PLANNING COMMISSION MEETING

PLANNING COMMISSION
FINDINGS OF FACT
RVW25-000028
TYPE III DECISION PROCESS

REQUEST: To approve an 84-room extended stay hotel and associated maintenance shed.

PROPOSED SITE PLAN
 PNJD INC
 BOB DAYAL
 BOARDMAN, OREGON
 TITLE: PNJD INC, ATTN: BOB DAYAL
 CLIENT: 82000 WALLOWA ROAD KENNEWICK, WA 99338

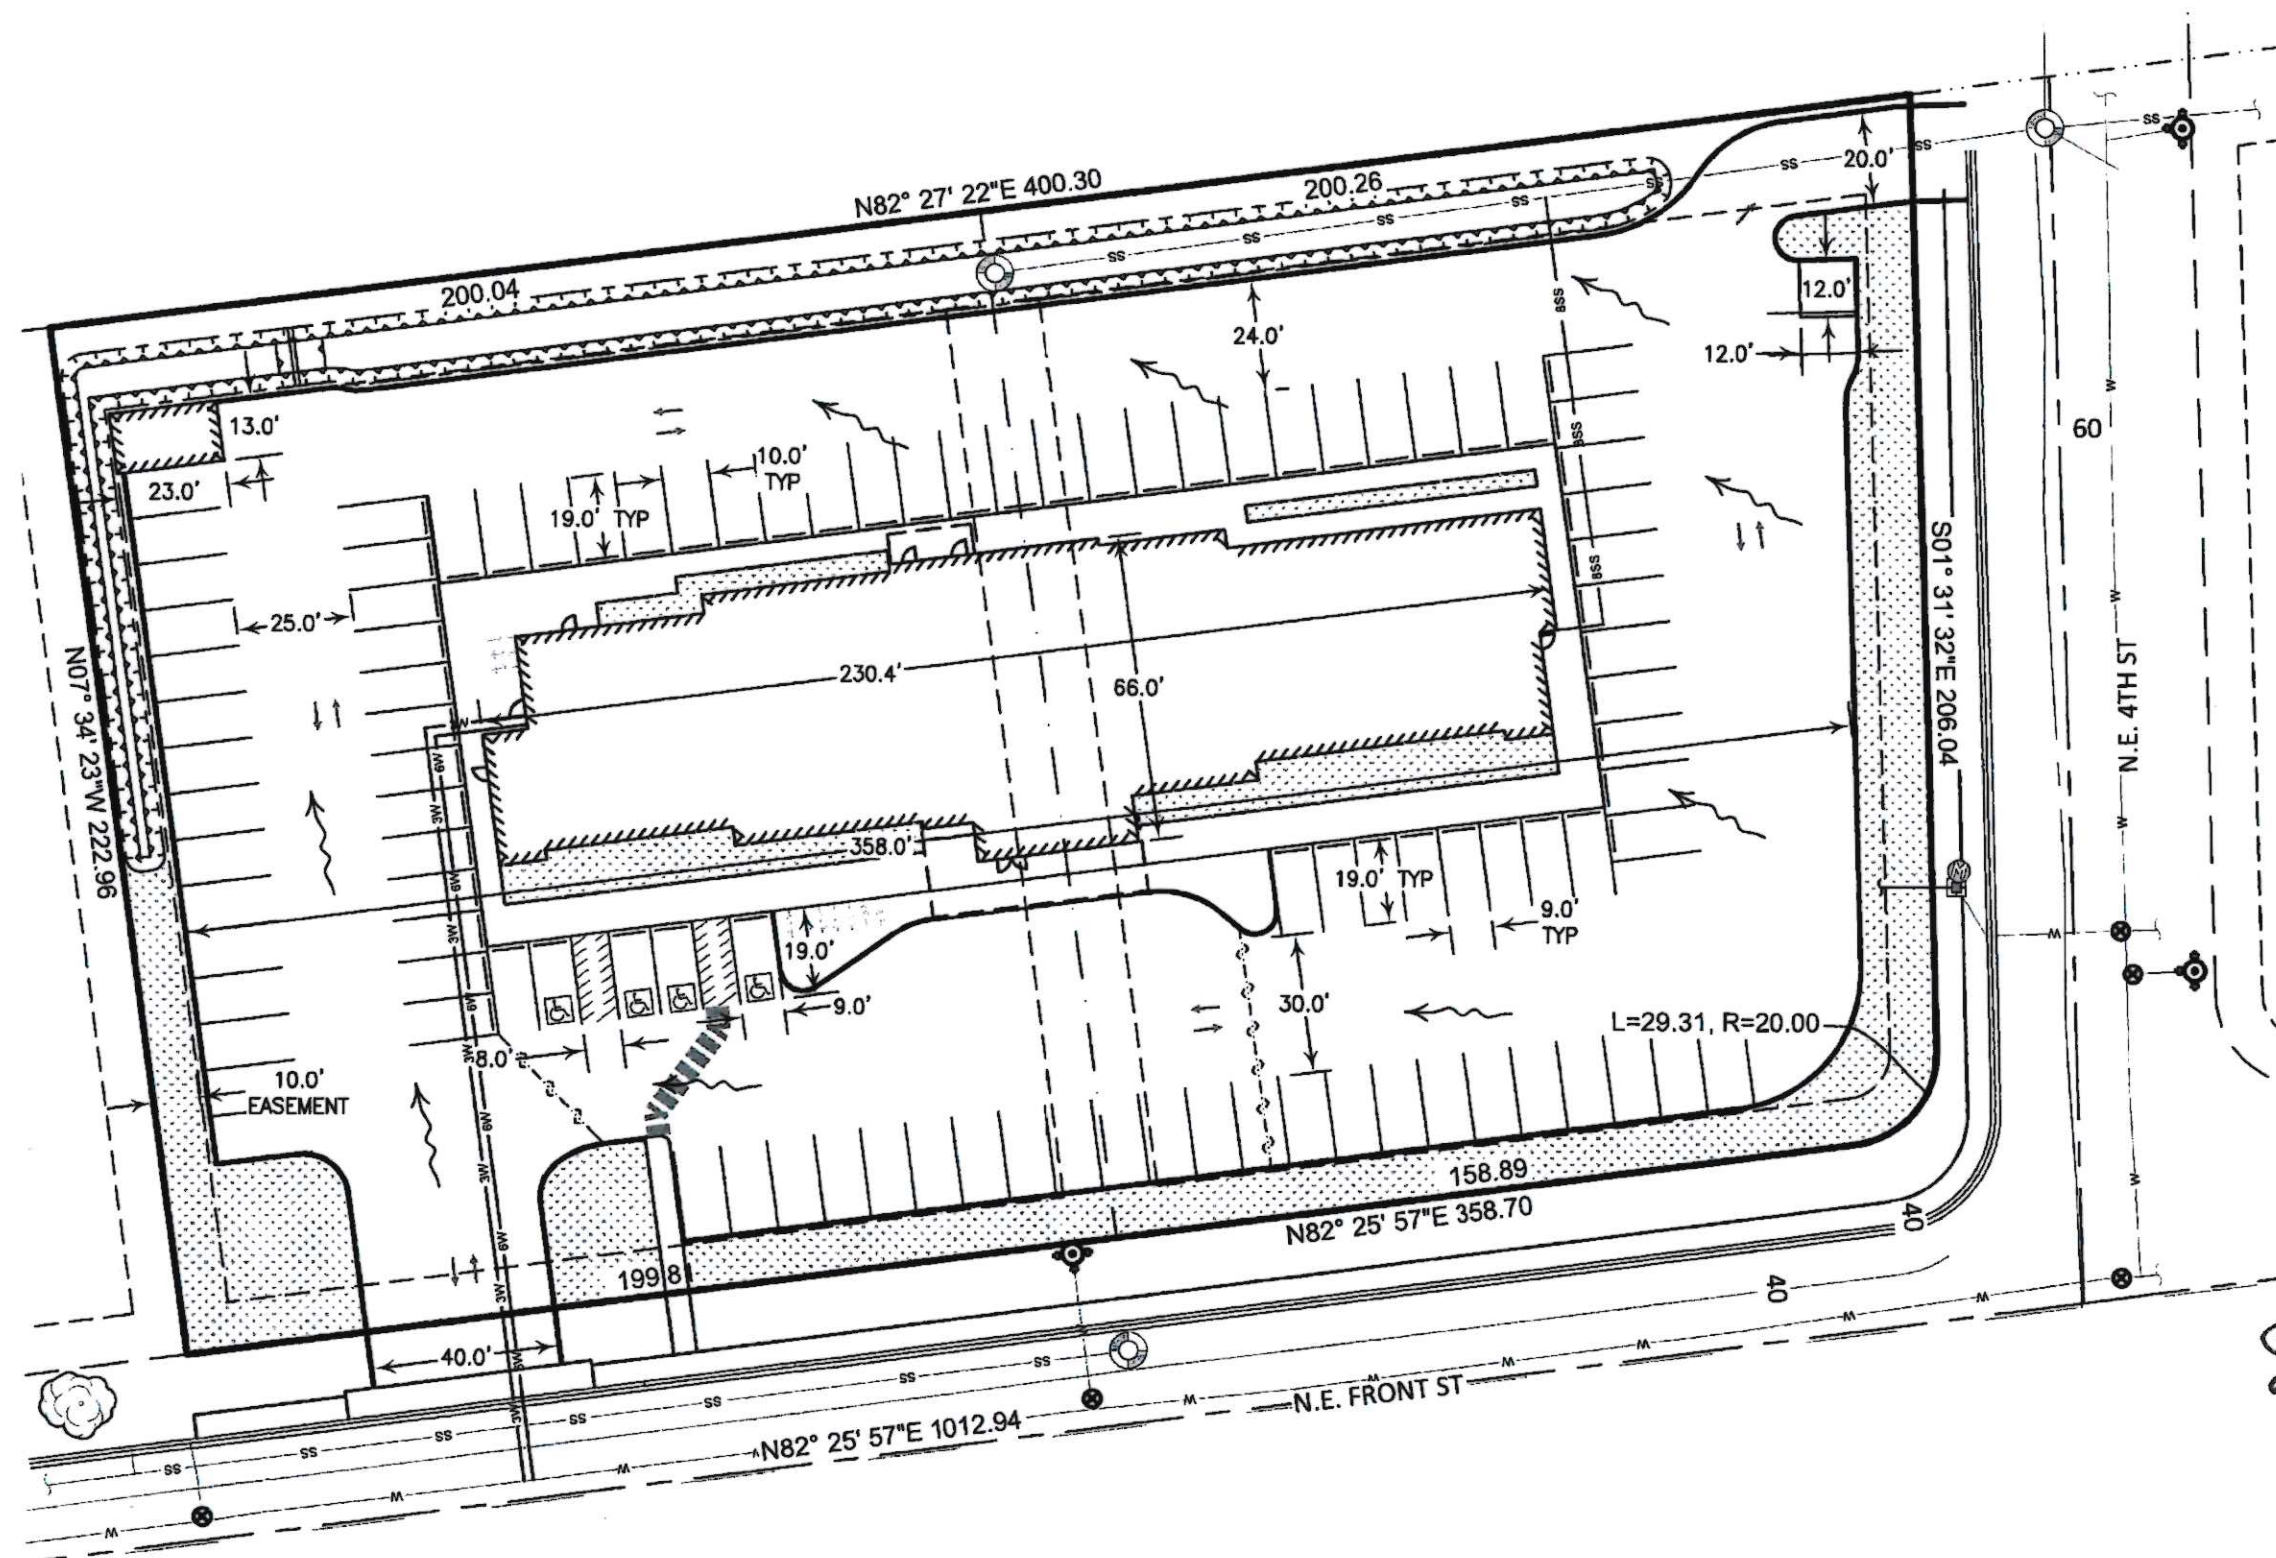
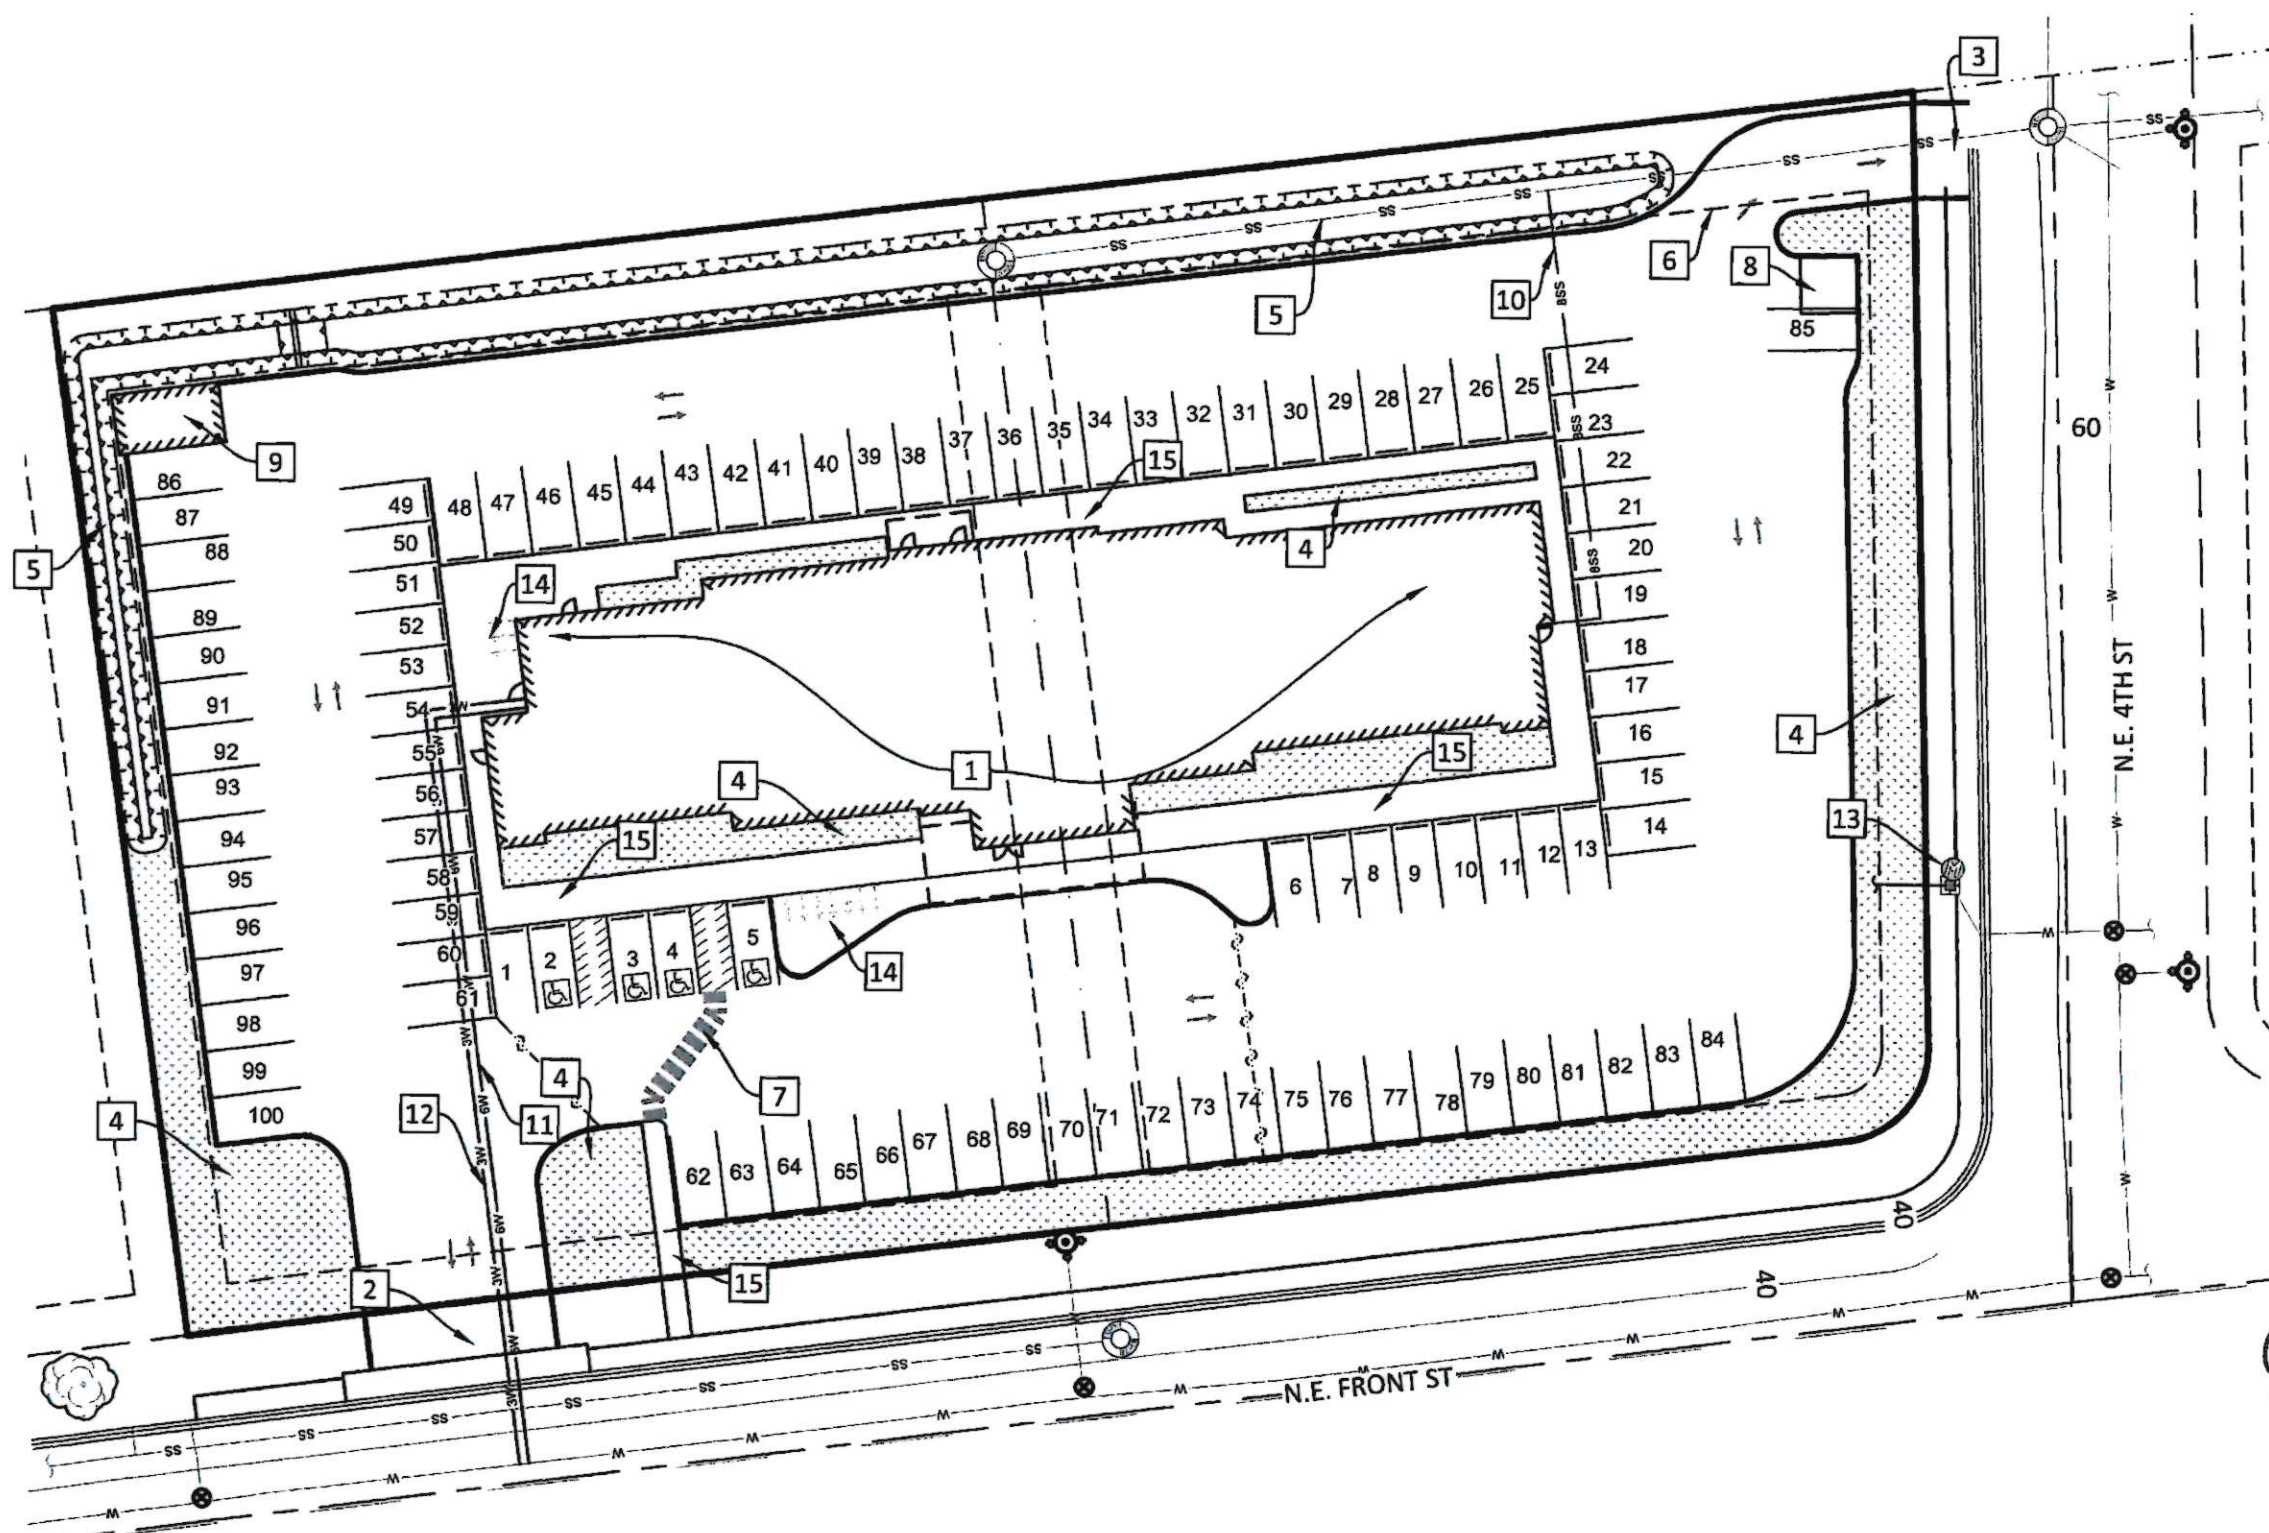
The preliminary site plan identifies two access points. One access will be used as an entrance and exit, and the other will be used specifically as an exit. Both will require an Access Permit. An address permit will also be required. This is listed as a Condition of Approval.

There will be two driveway access points: one along NE Front Street, measuring 40 feet in width, and a second along 4th Street, measuring 20 feet in width. This criterion is met.

There are 84 proposed rooms which, based on this standard, would require 85 parking spaces. The submitted site plan shows 100 spaces. This standard is met if development occurs consistent with the submitted site plan.

The applicant has submitted a site plan that shows four ADA parking spaces meeting this requirement if development occurs consistent with the submitted site plan.

The hotel will be required to have at least 10 bicycle parking spaces. It is shown in the site plan that there will be 10 bicycle parking spaces. The applicant shall comply with all bicycle parking requirements. This is listed as a Condition of Approval.
